UNITED STATES PATENT AND TRADEMARK OFFICE

APPLICATION NO.	FILING DATE	FIRST NAMED INVENTOR	ATTORNEY DOCKET NO.	CONFIRMATION NO.
10/765,117	01/28/2004	Goran Pantzar	024445-446	9711

Office Action Summary

DETAILED ACTION

FIG. 11

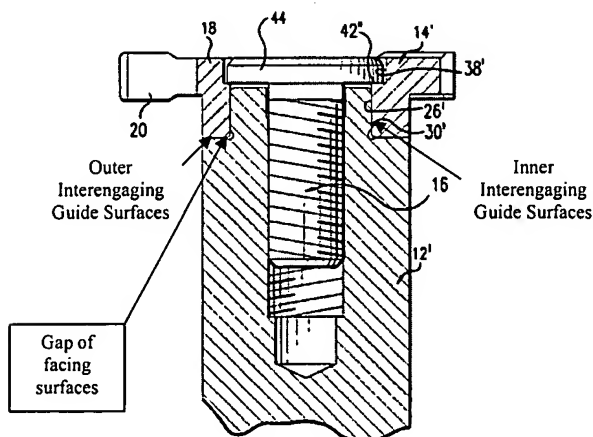
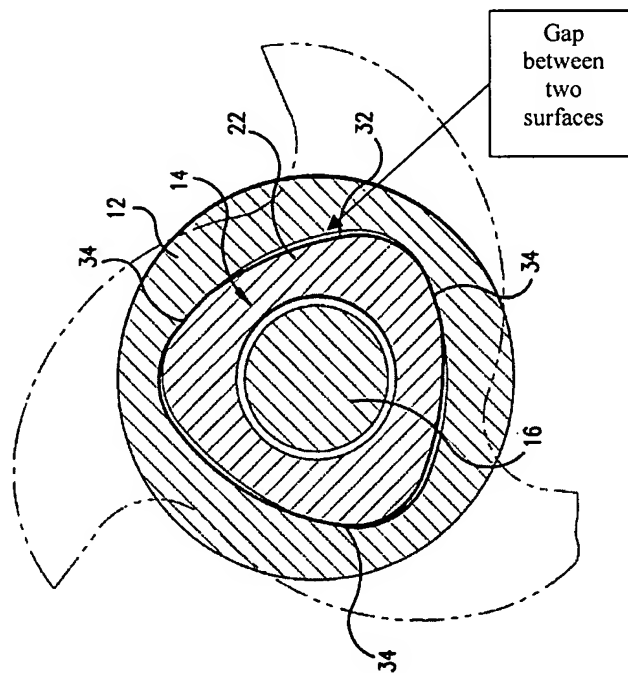
'263 teaches first and second bodies 14, 12 (see figure 4, for example), the first tool body 14 with a male member (area 22 of figure 4) and the second tool body 12 with a female member (area 50 of figure 4); outer and inner interengaging guide surfaces (see fig. 11 below); the male and female parts having a generally triangular cross section (see figures 1 and 3, for example); a force applying screw 16 (see figure 4, for example).

Regarding claim 1, as is seen in the above annotated Figure 11, and below Figure 6, '263 teaches the first and second tool bodies (12, 14) with first and second end surfaces facing each other in a non-contacting relationship when the tool bodies are connected (see also Figure 4 in the area located between the tools for another area of non-contact).
